## ORIGINATION FORM

Proposed Revisions to a Standard Plans Index  
(Please provide all information — Incomplete forms will be returned)

Index Number: 515-062  
Sheet Number (s): 6  
Index Title: Pedestrian/Bicycle Railing (Aluminum)

**TYPE 2 - CHAIN-LINK (Continuous Infill Panel)**

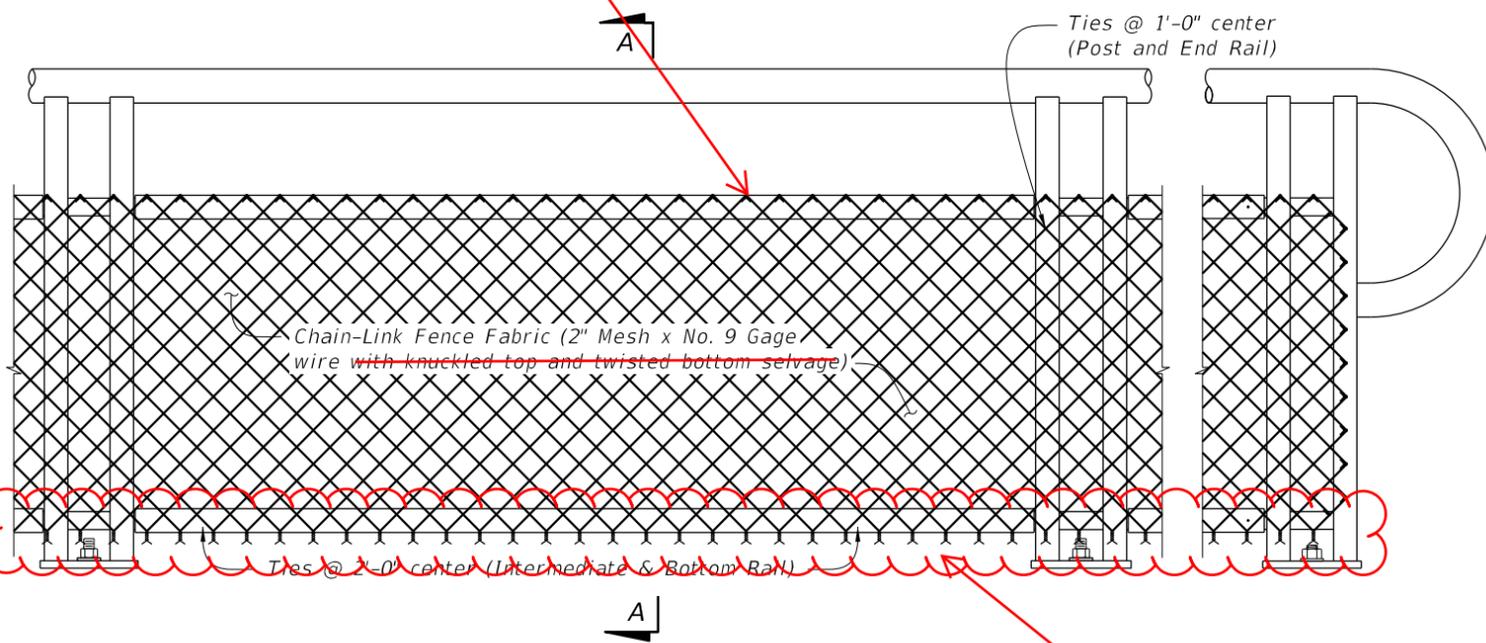
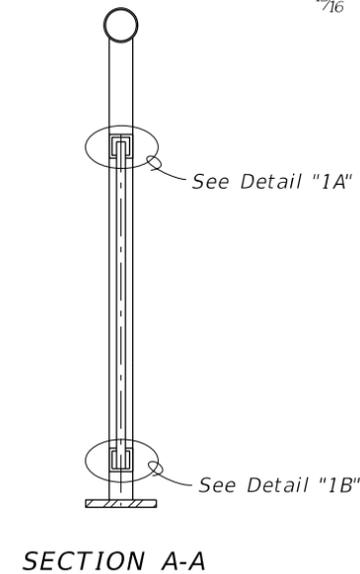
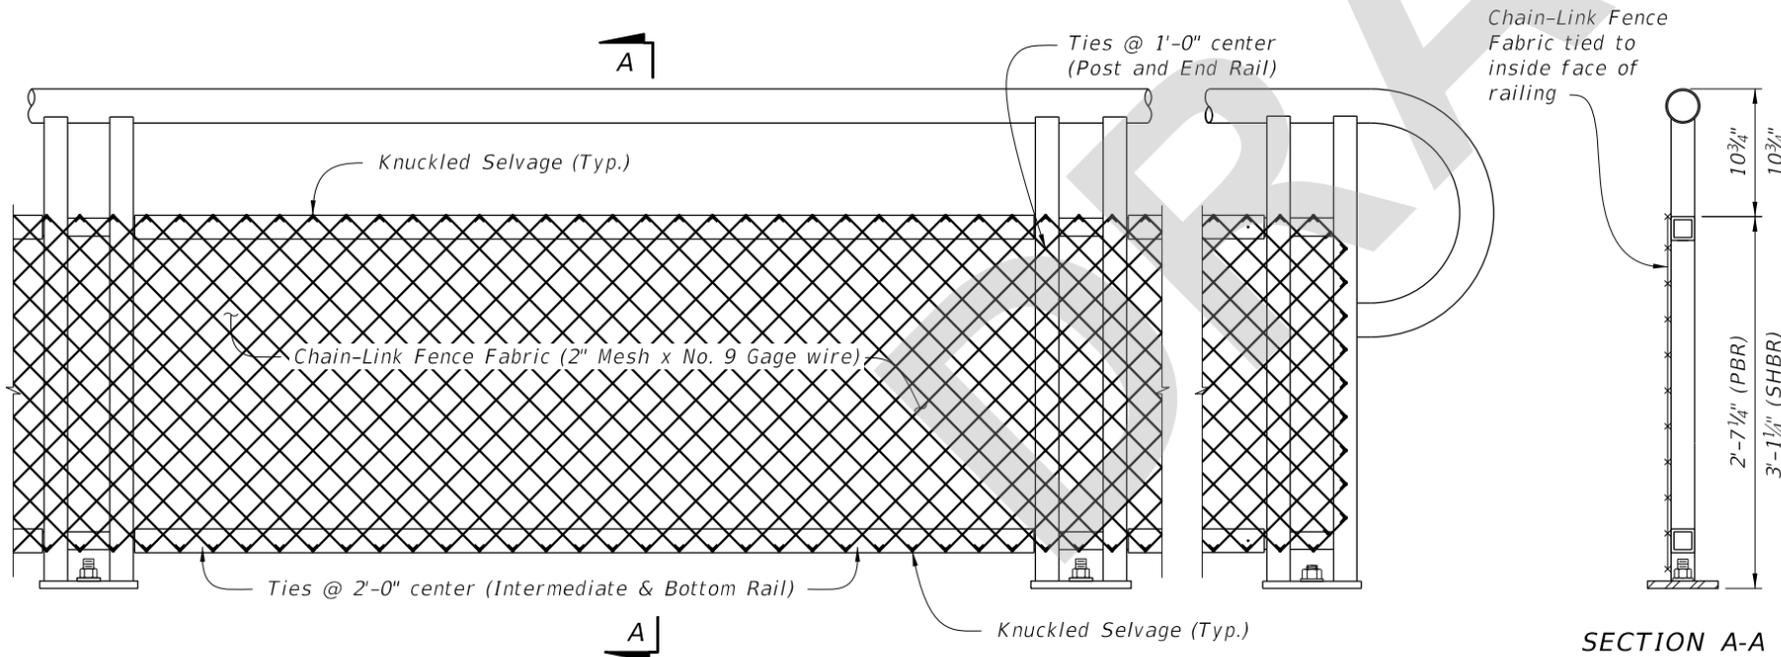
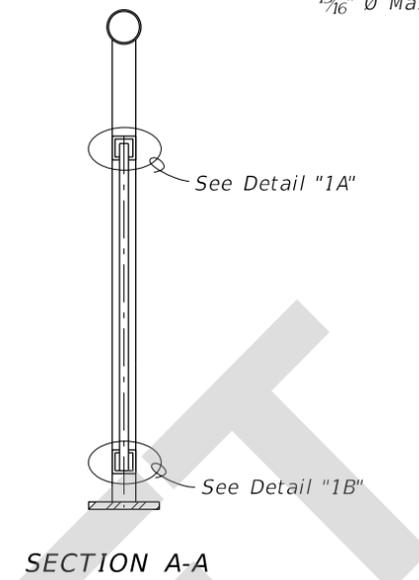
Sheet 6- Added knuckled selvage as an option to the chain-link railing option

**Knuckled Selvage (Typ.)**

**Redraw as knuckled**

**Knuckled Selvage (Typ.)**

The selvage requirements detailed on Index 515-062 were based on a conservative approach to secure the bottom edge. Using knuckle selvage top and bottom would be acceptable.

TABLE 2 - CHAIN-LINK PANEL COMPONENT MATERIALS		
COMPONENT	ASTM	COMPONENT INFORMATION
Chain-Link Fence Fabric (2" mesh with knuckled top and bottom selvage)	A392	Zinc-Coated Steel - No. 9 gage (coated wire diameter), Class 2 Coating
	A491	Aluminum-Coated Steel - No. 9 gage (coated wire diameter)
	F668	Polyvinyl Chloride (PVC) Coated Steel - No. 9 gage Zinc-Coated Wire (metallic-coated core wire diameter) ~ See Plans for specified color of PVC.
Tie Wires	F626	Zinc-Coated Steel Wire - No. 9 gage with coating to match Chain-Link Fence Fabric.
Tension Bars	F626	3/16" (min. thickness) x 3/4" (min. width) x 2'-3' (min. height) Steel Bars
Miscellaneous Fence Components	F626	Zinc-Coated Steel
